SUBJECT: CALVERT CLIFFS NUCLEAR POWER PLANT, UNITS 1 AND 2 – ISSUANCE
OF AMENDMENT NOS. 323 AND 301 TO CHANGE TO LOW LEVEL
REFUELING WATER TANK (CAC NOS. MF9491 AND MF9492;
EPID L-2017-LLA-0191)

SAFETY EVALUATION BY THE OFFICE OF NUCLEAR REACTOR REGULATION

CALVERT CLIFFS NUCLEAR POWER PLANT, UNITS 1 AND 2

Figure 1. Distance from Top of Outlet Pipes to the Bottom of the RWT

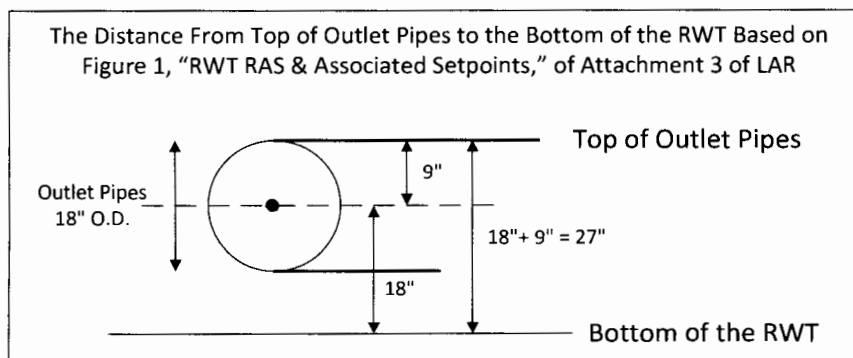
The NRC staff reviewed calculation CA10206, "RWT Level RAS Setpoint Determination," Attachment 3 of the LAR, to verify that the distance from the bottom of the RWT to the top of the outlet pipe is an appropriate setting for automatic protective action that will correct an abnormal situation before a safety limit is exceeded.

The current TS Table 3.3.4-1 RWT level-low AV of ≥ 24 inches is nonconservative, as shown in Figure 1 above. In order to minimize or eliminate air entraining in the ECCS during the injection phase following a LOCA, the licensee proposed to raise this parameter from greater than 24 inches to 42 inches. Consequently, the staff finds this proposed change to be acceptable, because the proposed RWT level is higher than the required water level to prevent vortexing.

Figure 2. NRC Staff Margin Calculation

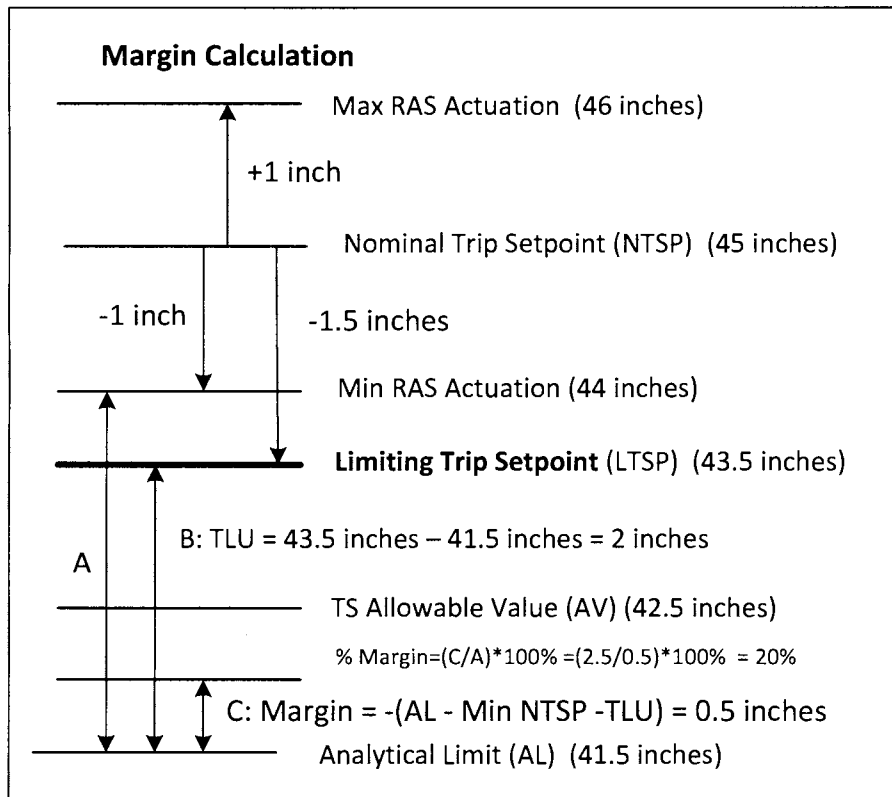
Based on RG 1.105, Revision 3, the NRC staff calculated the TLU as shown in Figure 2 below.

The NRC staff used RG 1.105, as shown in Figure 2 above, to independently calculate and verify the margin between the NTSP and associated AL for the worst-case minimum RAS actuation (which requires an as-found value of at least 44 inches).

- (3) The proposed AL will provide a sufficient margin (greater than or equal to 20 percent, as shown in the margin calculation above) that exists between the NTSP (as-found value) and the AL. This margin reflects the trip setpoint, which has been chosen to assure that a trip or safety actuation occurs before the process reaches the AL level to satisfy the 10 CFR 50.36(c)(1)(ii)(A) requirements. In addition, the RWT level switch function meets the performance criteria of RG 1.105.
